Trojan Nuclear Plant
Docket 50-344
License NPF-1

Enclosed are the responses prepared by Bechtel Power Corp. to informal questions raised by staff members during their site visit on June 13-14, 1979. This visit and the questions responded to herein concern construction details related to the structural modifications of the Control-Fuel-Auxiliary Building Complex.

Responses to NRC Questions Raised
During the June 13-14 Visit
to Trojan Nuclear Plant

BECHTEL	
770 JAVAS AVENUE, SAN FRANCISCO, CALIF. 4	
CONTROL BUILDING	
WALL PLATE RIGGING	
13097	PK-1

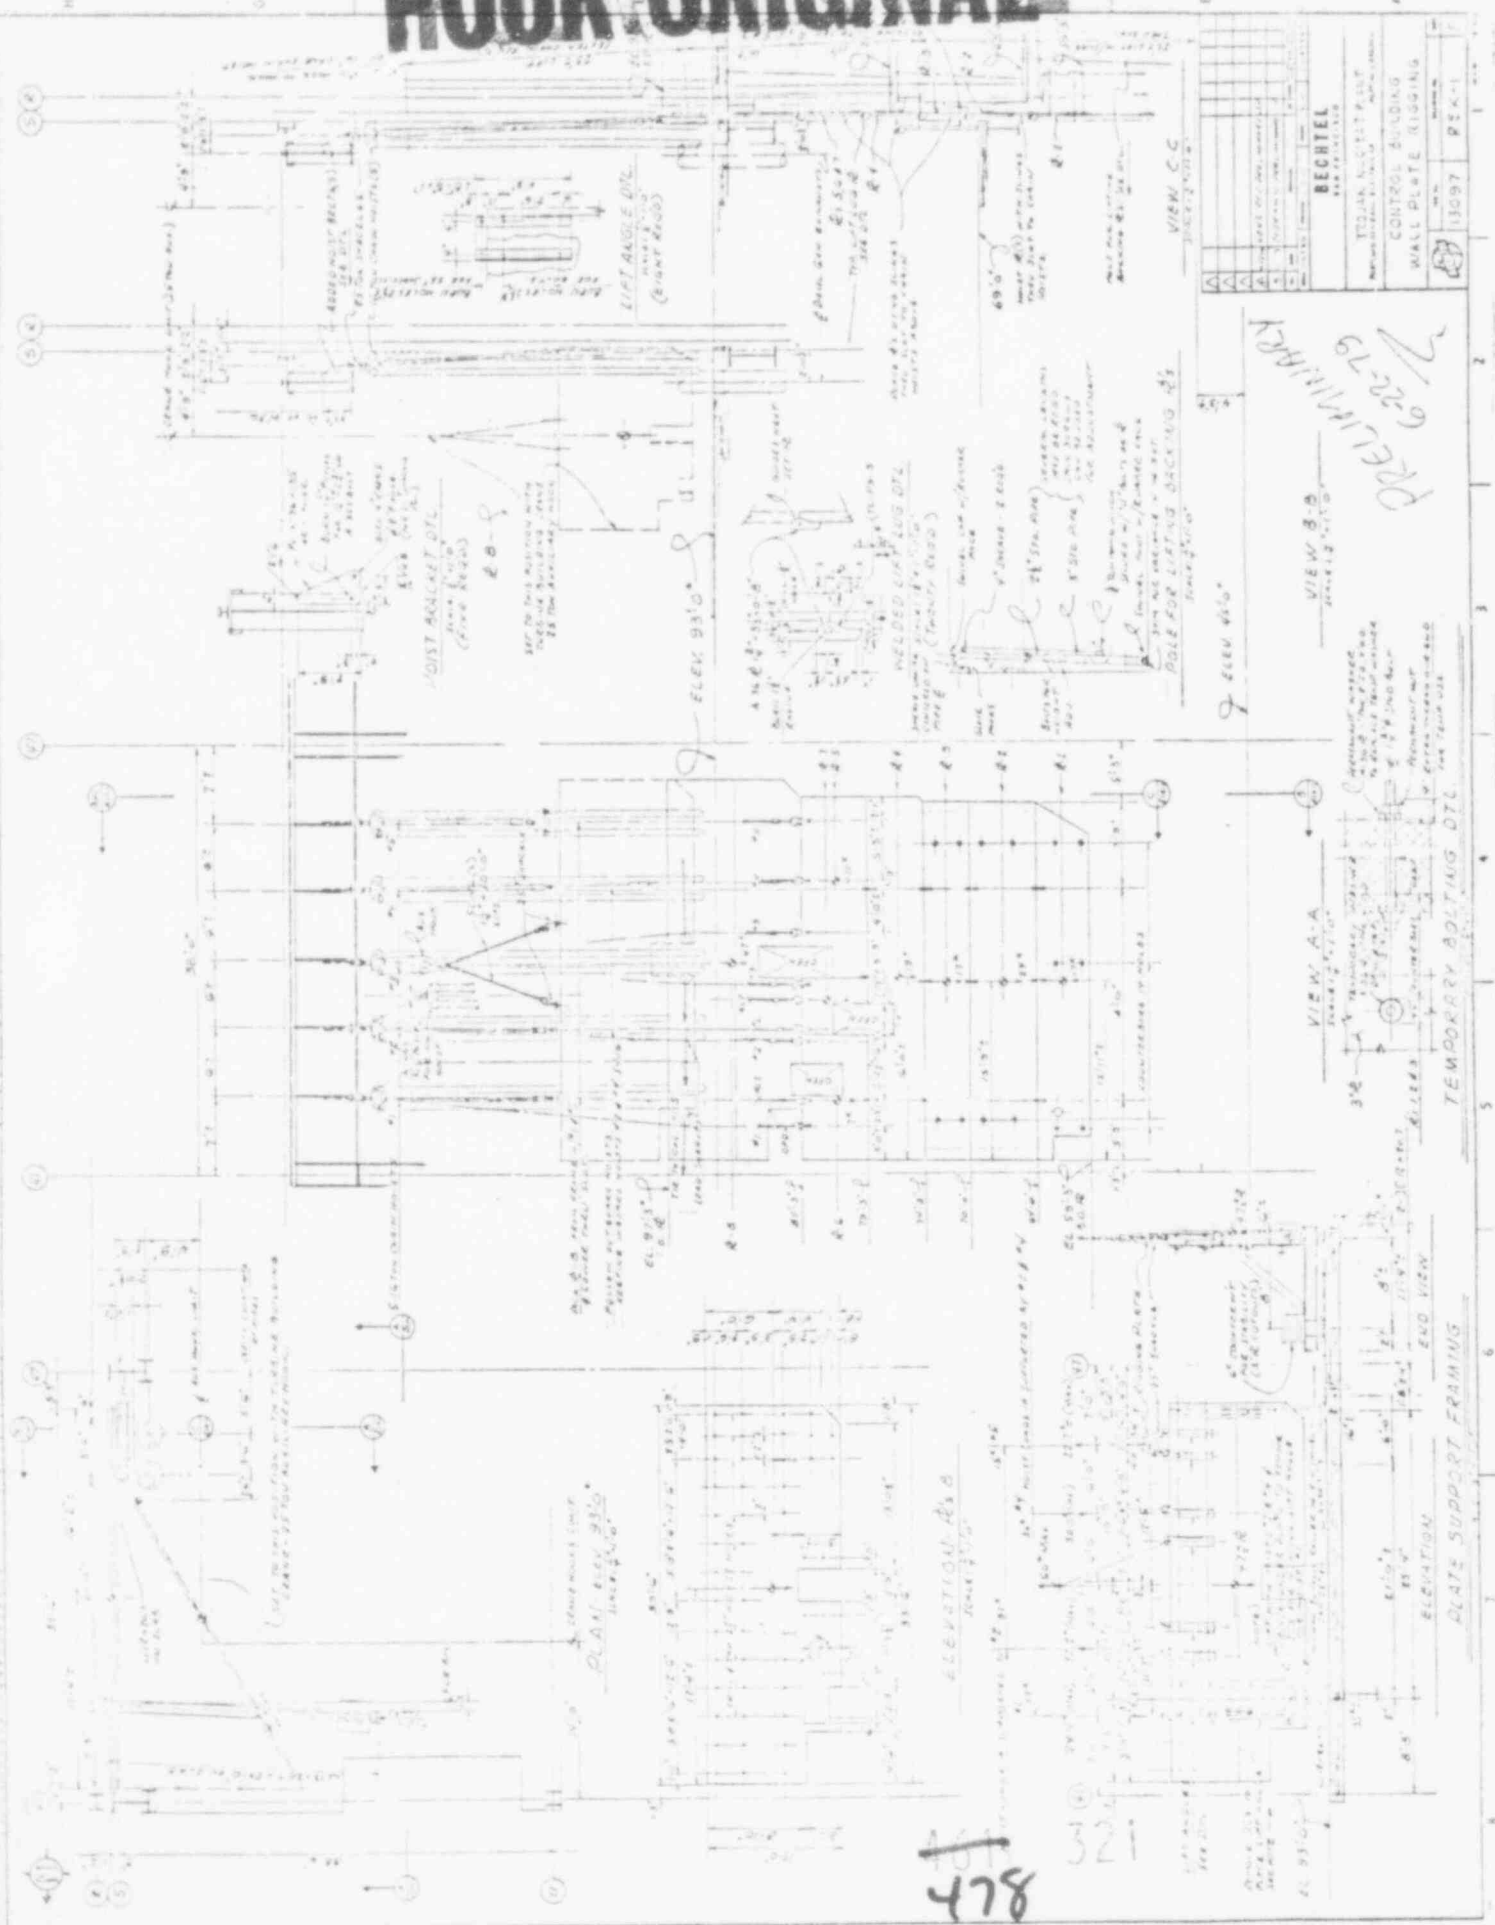
Steel plates for the west face of the wall from El 59 ft 3 in. to 97 ft 3 in. will be delivered and unloaded at ground level, El. 45 ft. Steel plates to be installed consist of 8 sections and will be numbered 1 through 8 for identification (see drawing RSK-1). Steel Plates No. 1 through 6 will be hoisted and installed below all the cable tray. Steel Plates No. 7 and 8 will be hoisted through the opening below the Turbine Building crane and lowered over the cable trays from above the El. 93 ft floor.

This chain hoist will not be loaded but will remain taut to receive the load should either of the two outboard chain hoists malfunction. Drawing RSK-1 shows details of the hoisting operations.
